# CITY OF ALBUQUERQUE

**RE: 1542 Wells Dr. NE**  
**Grading and Drainage Plan**  
**Engineer's Stamp Date: 08/20/20**  
**Engineer's Certification Date: 04/30/21**  
**Hydrology File: J23D029**

## DRAINAGE AND TRANSPORTATION INFORMATION SHEET (REV 6/2018)

**Project Title:** 1542 WELLS NE **Building Permit #:** \_\_\_\_\_ **Hydrology File #:** \_\_\_\_\_

ENGINEER'S SEAL	LOT 18-A BLK 13 REBOINTO SUB. 1542 WELLS DR.	DRAWN BY DEM
		DATE 8-21-20
		WELLS SITE.DWG
		SHEET # C1
		JOB #  _____
8/20/20	 <div>Rio Grande Engineering 1608 CENTRAL AVENUE SE SUITE 201 ALBUQUERQUE, NM 87106 (505) 872-0899</div>	
DAVID SOULE P.E. #14522

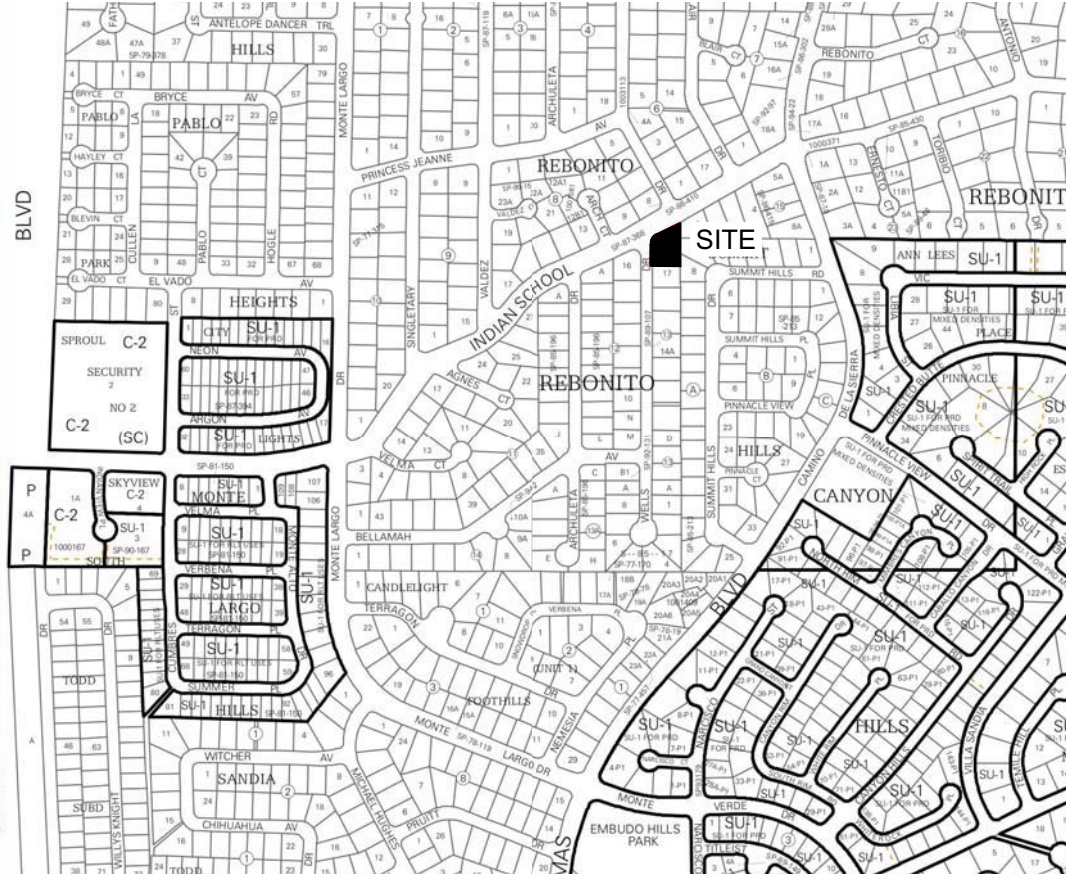
Based upon the information provided in your submittal received 05/13/2021 and site photos sent on 05/13/21, the Grading and Drainage Plan is approved for Building Permit and Building Pad Certification for 1542 Wells Dr. NE. Please attach a copy of this approved plan in the construction sets for Building Permit processing along with a copy of this letter.

Prior to approval in support of Permanent Release of Occupancy by Hydrology, Engineer Certification per the DPM checklist will be required.
